Idaho State University (ISU) arena inspection. Located in Pocatello, ID, ISU is the region's largest university system serving residents of Idaho, Wyoming, Utah, Montana and a host of other states and countries. Its location serves to add to the difficulties of maintaining athletic facilities like this one – the northern Rockies can be, at times, a harsh climate for both winter and summer. I'm somewhat surprised it wasn't covered in snow when I went to do the inspection.

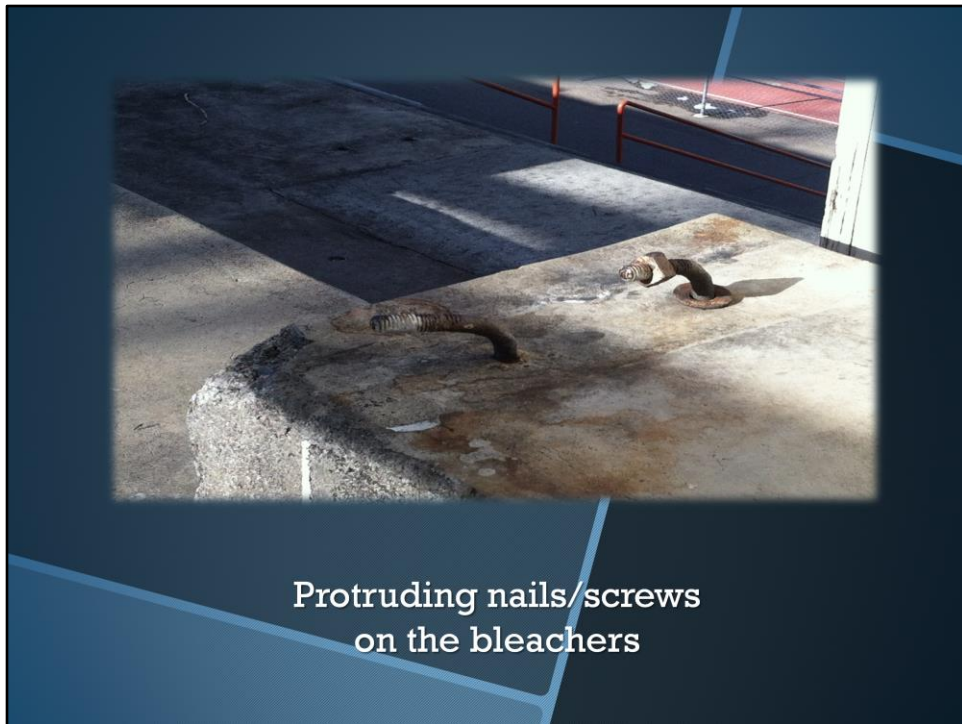
The picture doesn't fully show the hazard here, but there is one present. For example, just beyond the railing is a steep 10-15 foot drop-off onto concrete. The railing is approximately 36 inches tall, with no mid-rail. The problem here is children. It would be very easy for a child under this height to walk under the railing and fall to the concrete below. The bleachers are to the left in the picture – where most people would be facing the track and field – and should a child wander to the edge of the bleachers, they'd be exposed to the fall. To correct this, I would suggest that the university either add more railing or construct a barrier that would prevent those who could possibly do so from falling to the concrete below. Also, perhaps more grounds-keeping is in order to ensure a more suitable surface.

This is an obvious hazard that should not be present at a facility used as often as this. Apparently, the solution to this problem was to simply hammer the protrusions to an angle thought acceptable by those sitting in the bleachers. However, I don't agree with this. They should be removed if they serve no other purpose. Doing this would completely eliminate the hazard and provide a safe area for those to view the activities on the field.
